Terrace Guardrail Update

Children's Museum of Manhattan

March 19, 2025
Post Approval Amendment

Terrace Guardrail Current Proposed Design: Mesh 6'-0"

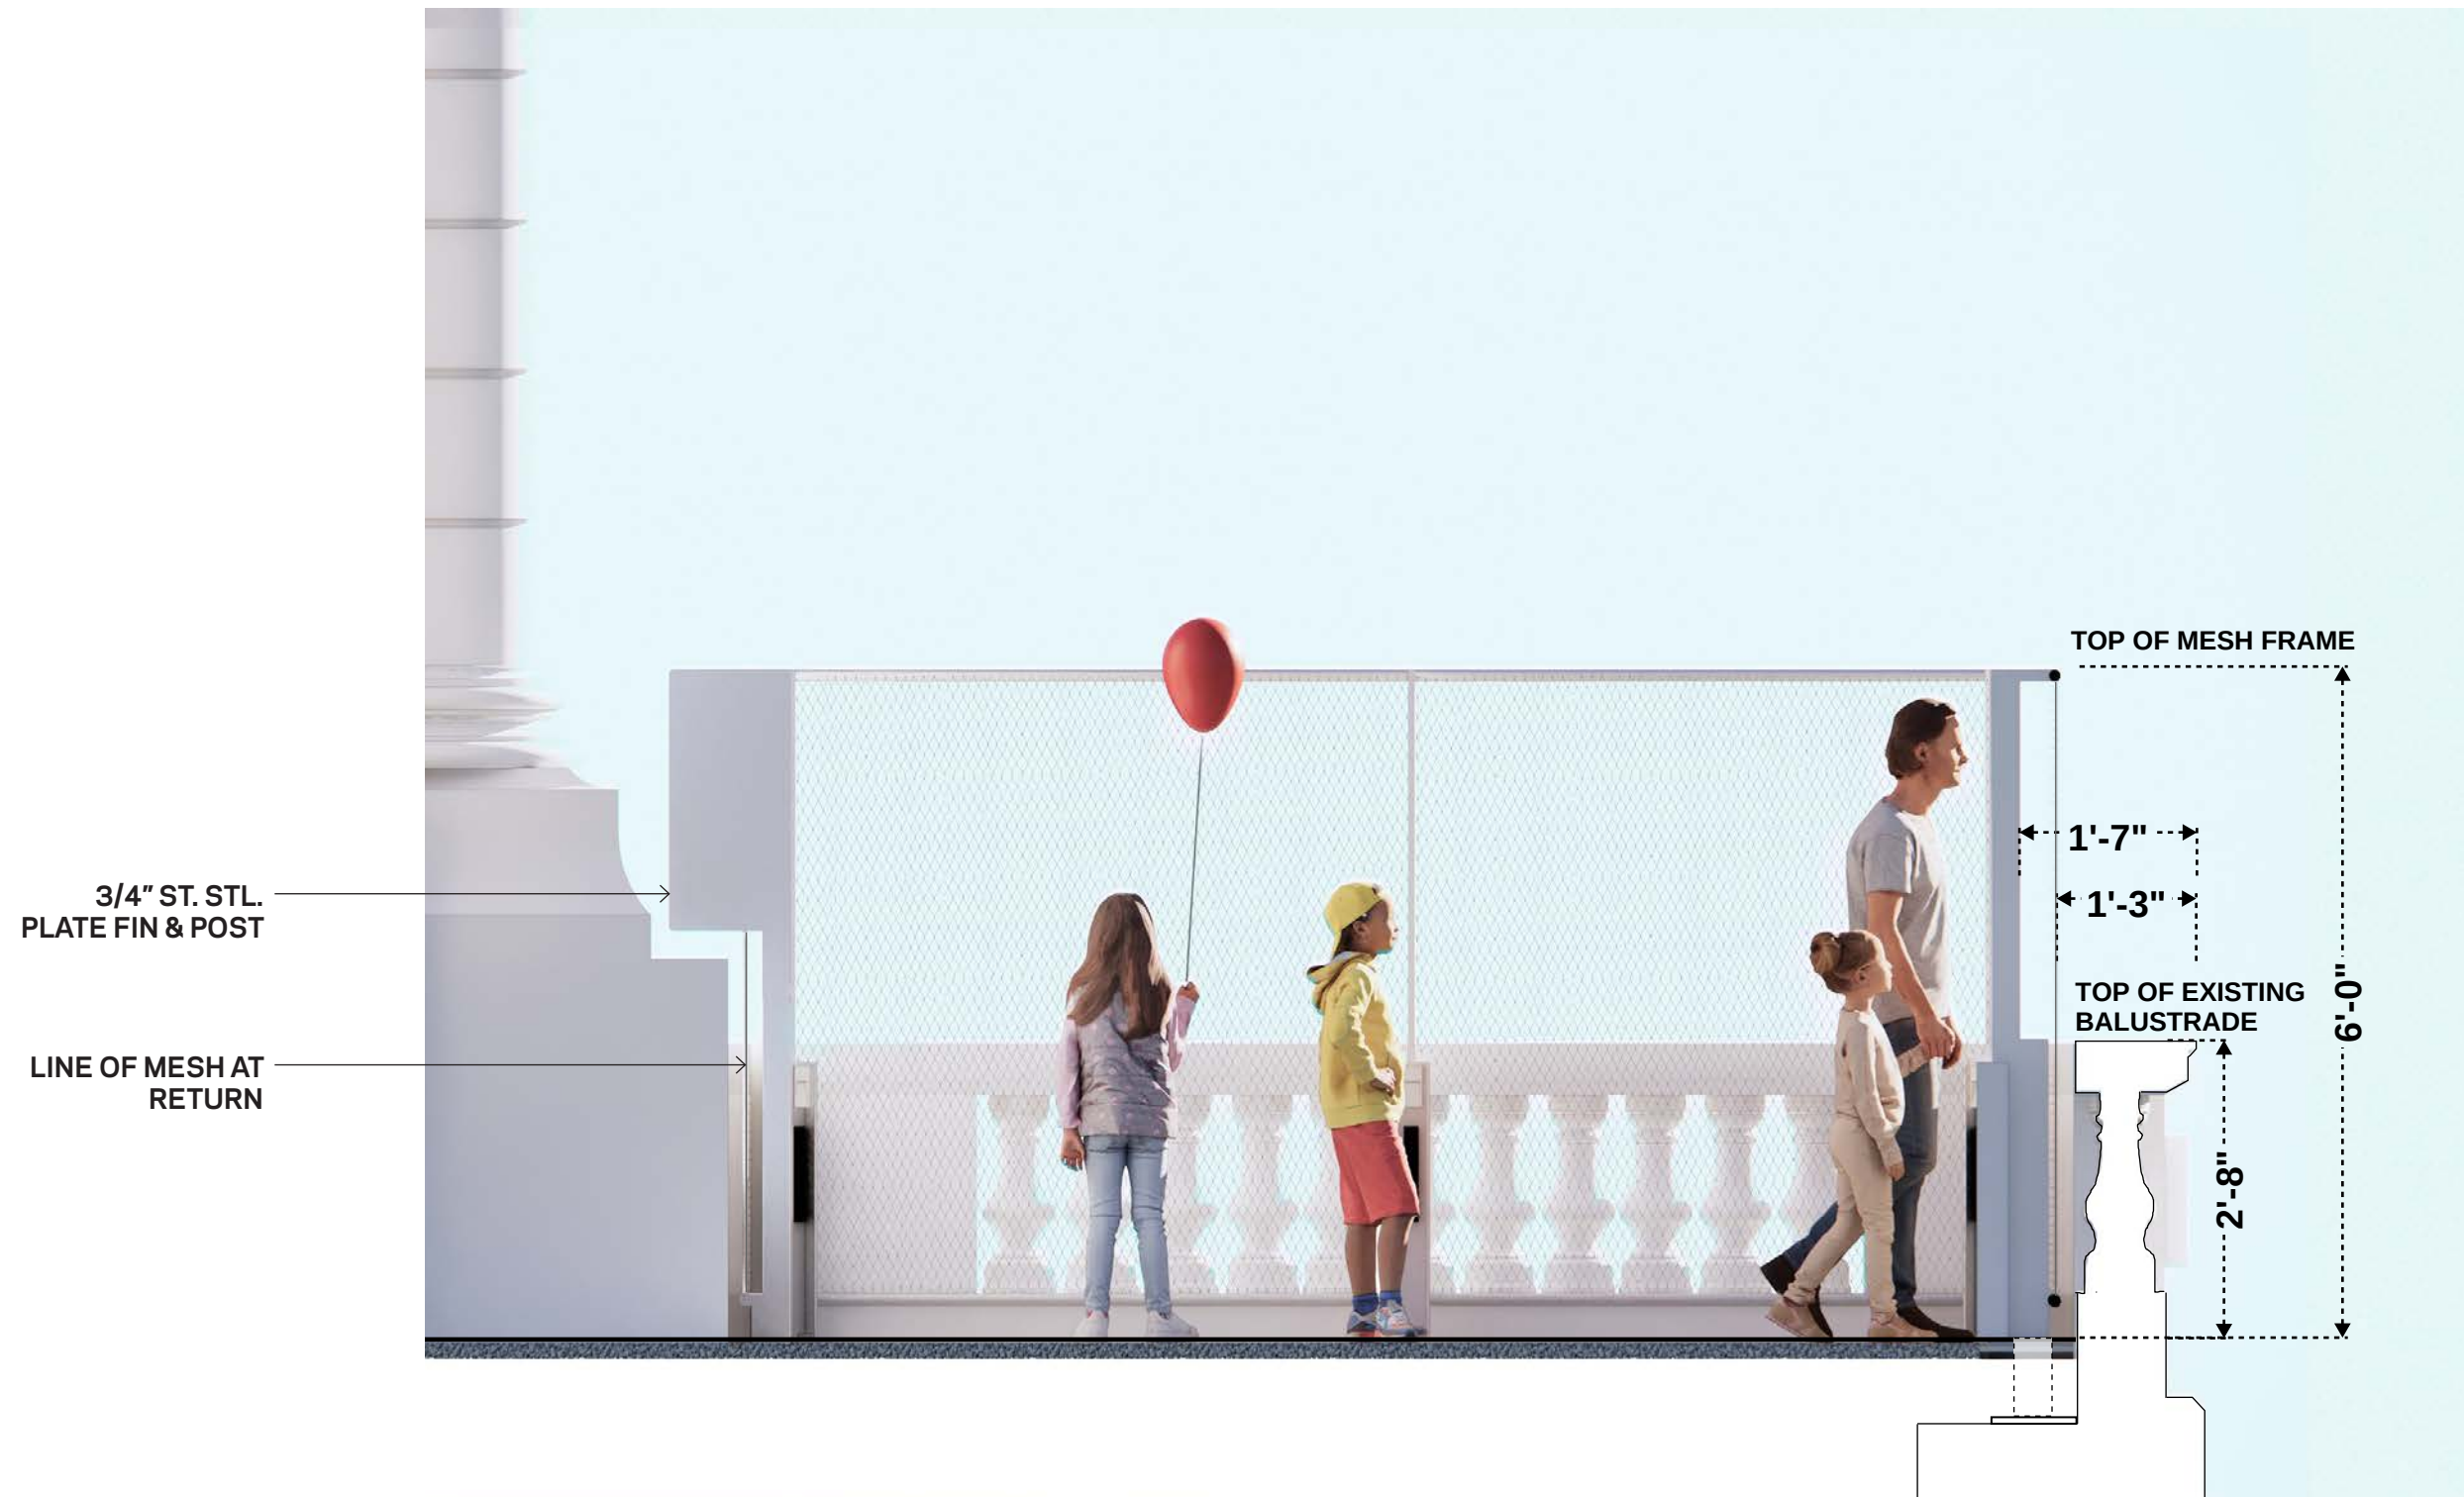
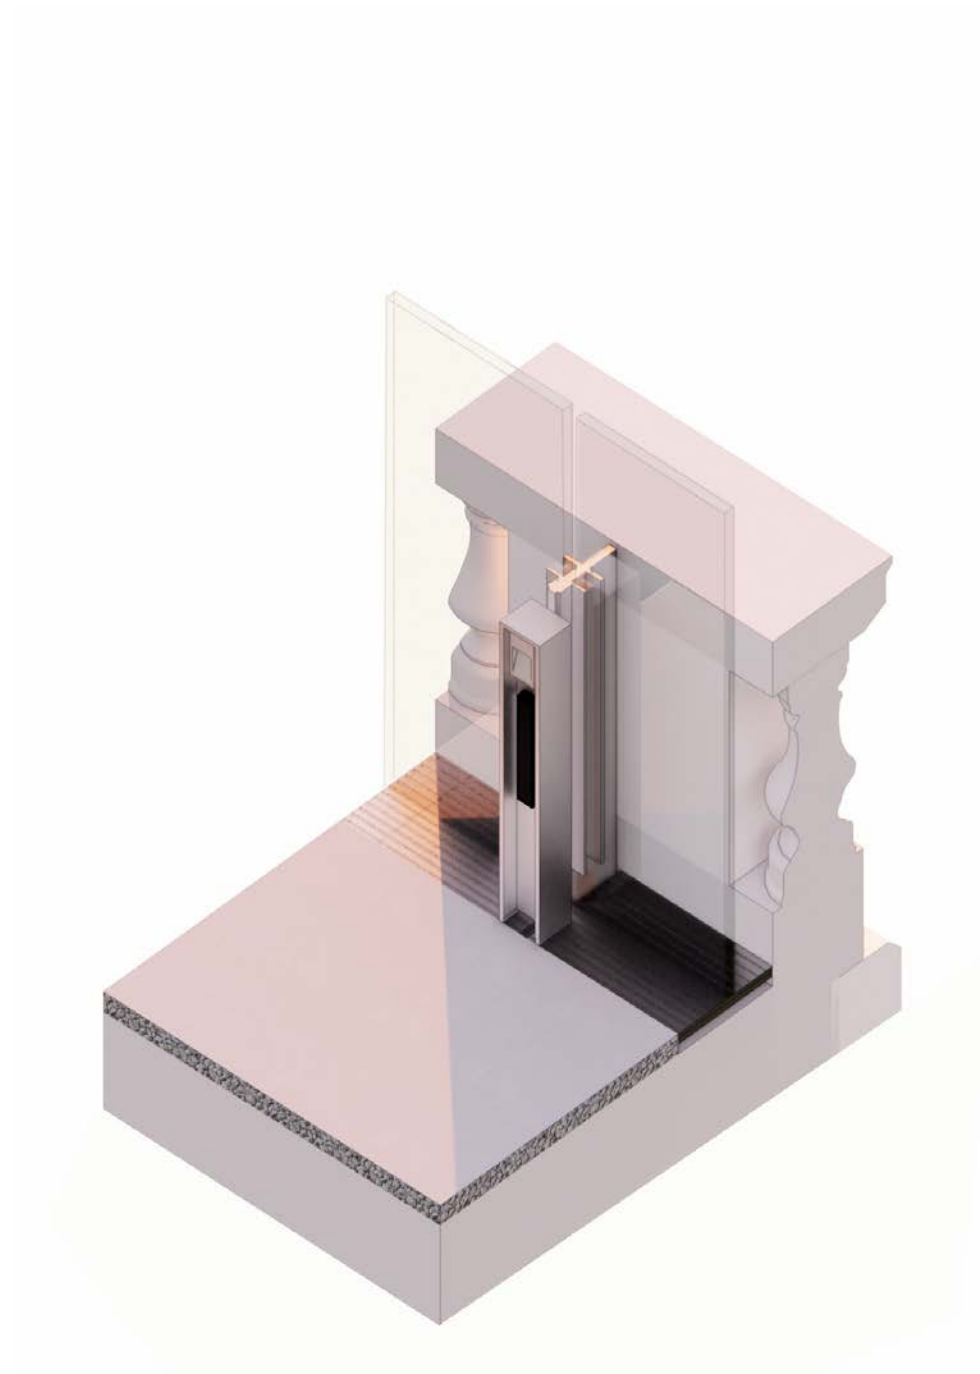
- **Increase guardrail height on the Terrace from 4'-0" to 6'-0" minimum, to address safety concerns**
- **Proposed design includes a stainless steel mesh with minimal frames integrated with the bollards and integrated light standards, simply designed**
- **Mesh is a contemporary intervention, clearly a new element, distinct from the granite tower and balustrade, with small enough apertures to deter climbing**
- **Mesh enhances the visitor experience on roof - feel breeze instead of being enclosed in glass**
- **Mesh is less reflective than glass and safer for birds**
- **Railing at center balcony is removed, a stainless steel frame and mesh gate is added to the center doorway for FDNY access only**

Terrace Guardrail Current Proposed Design: Mesh 6'-0" South Elevation

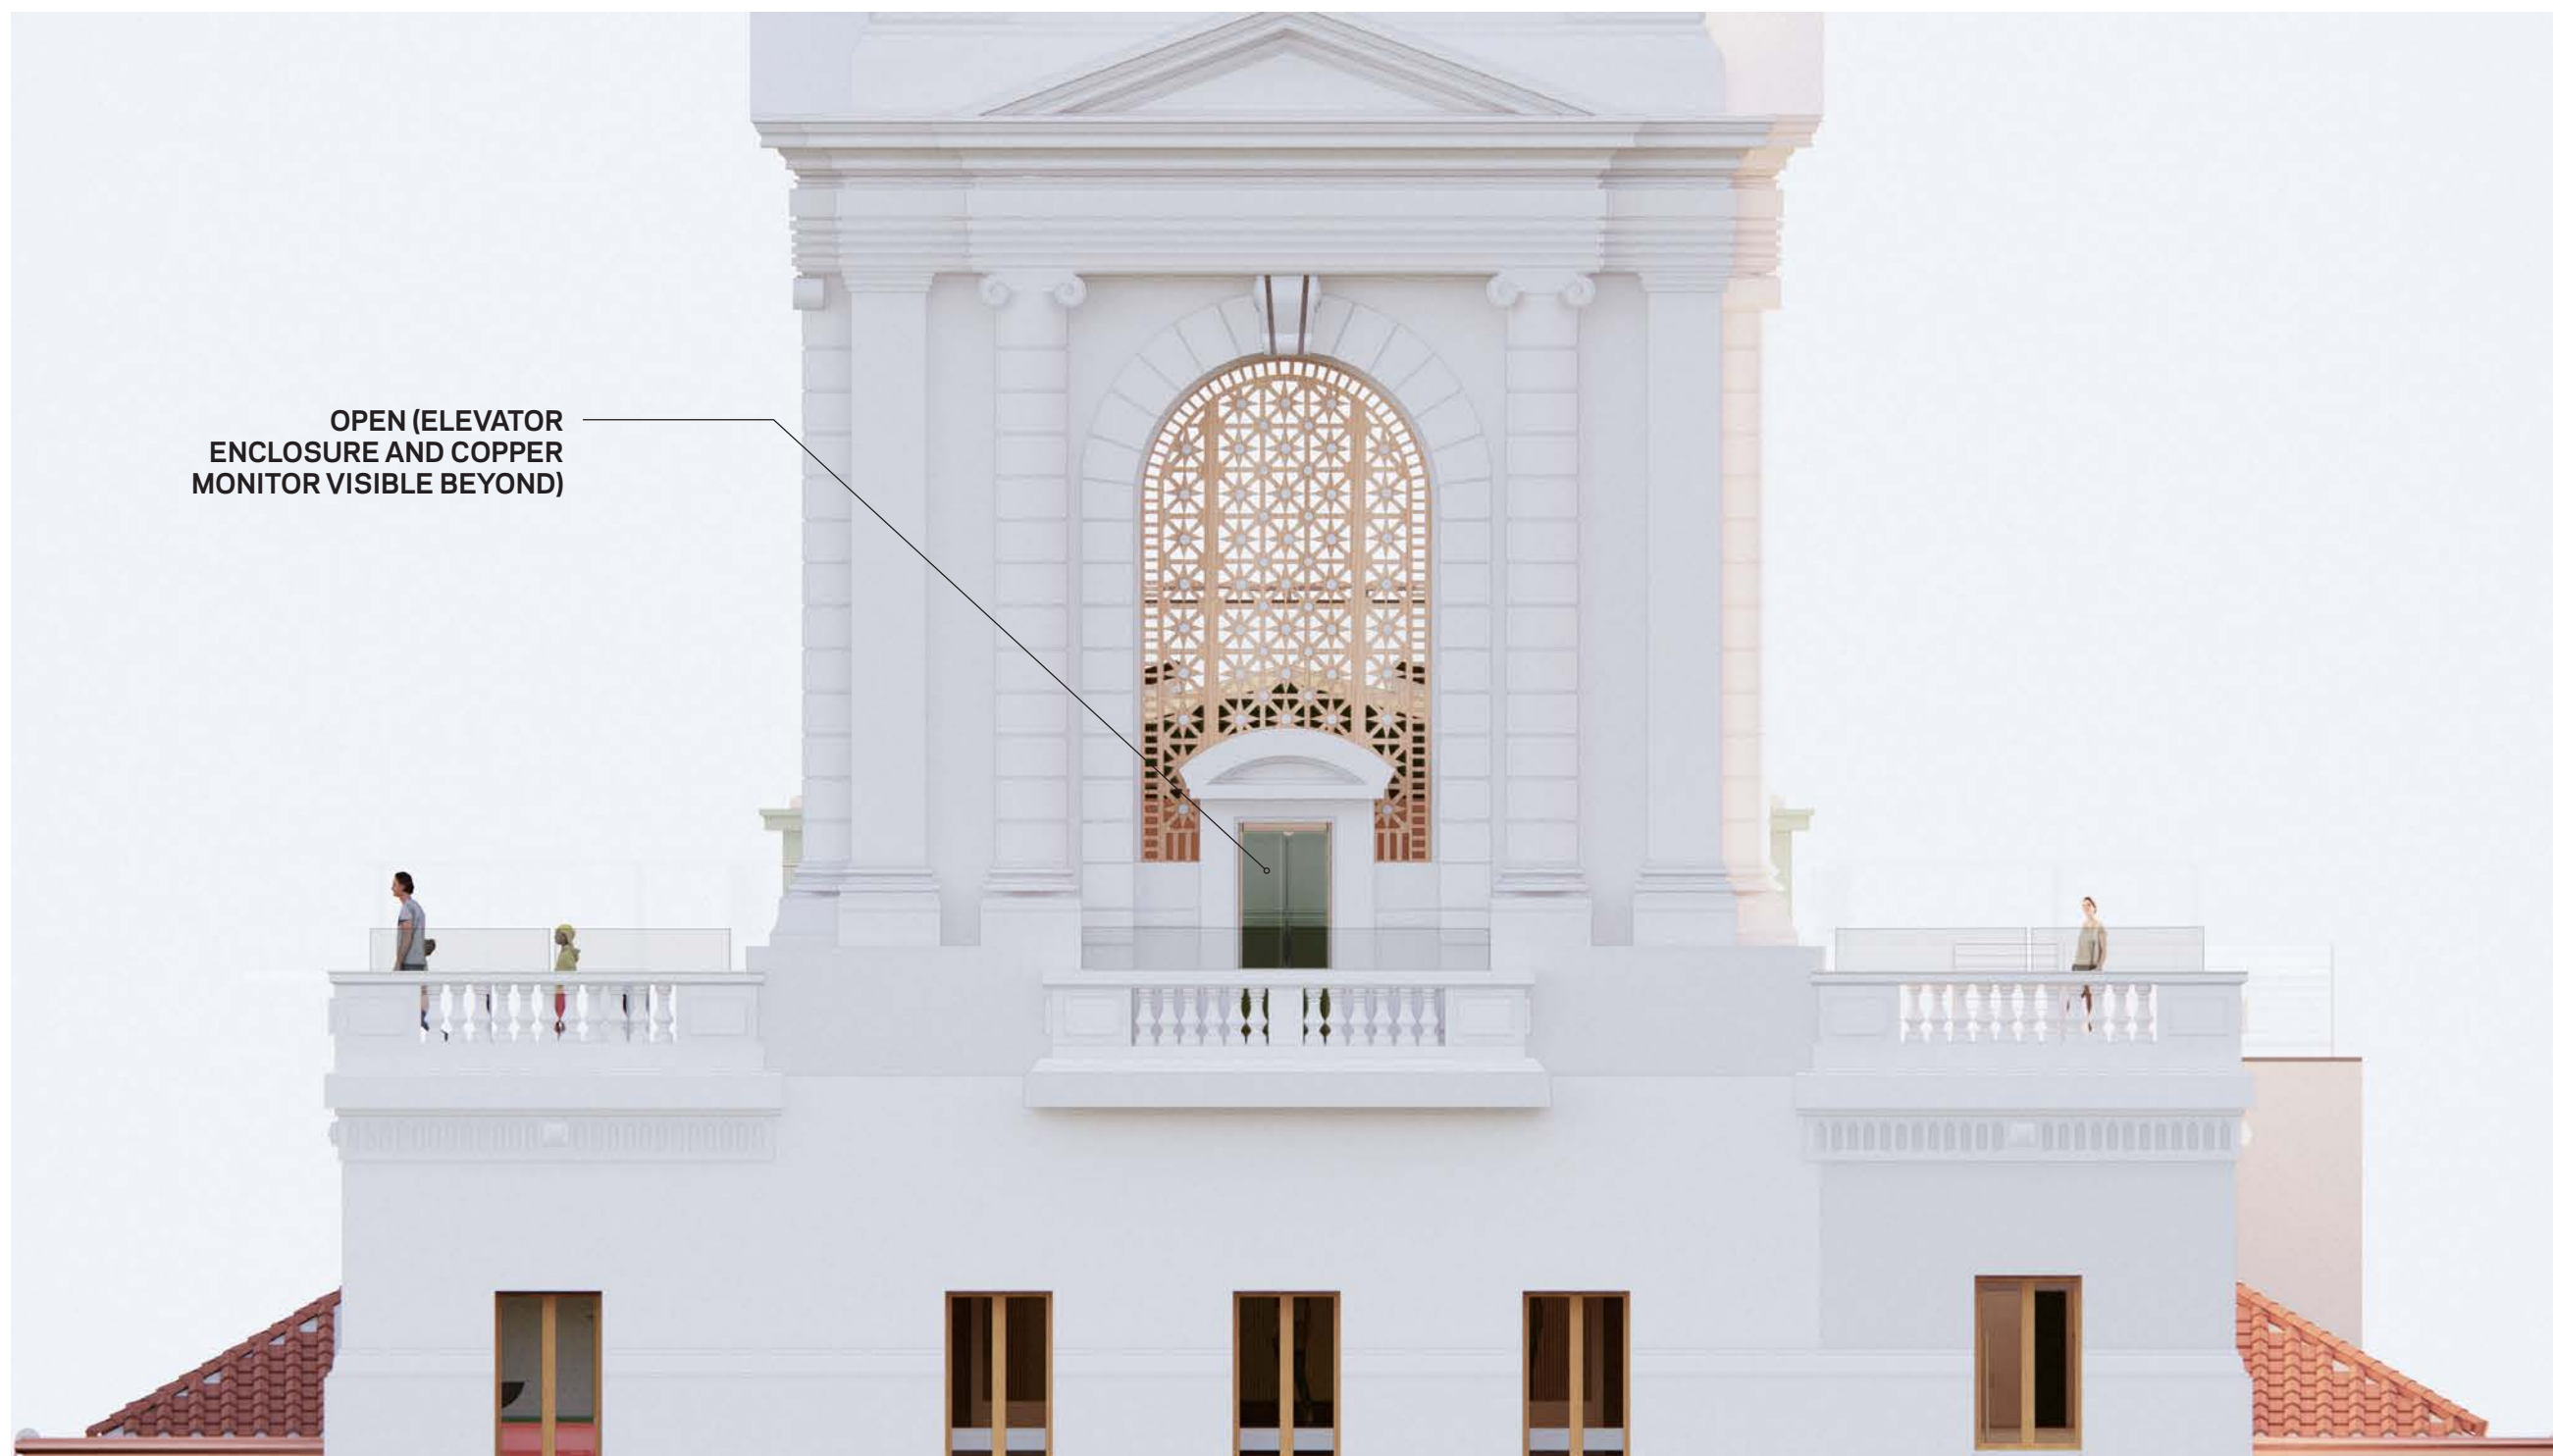
NO BOLLARD/
LIGHT AT END
POST
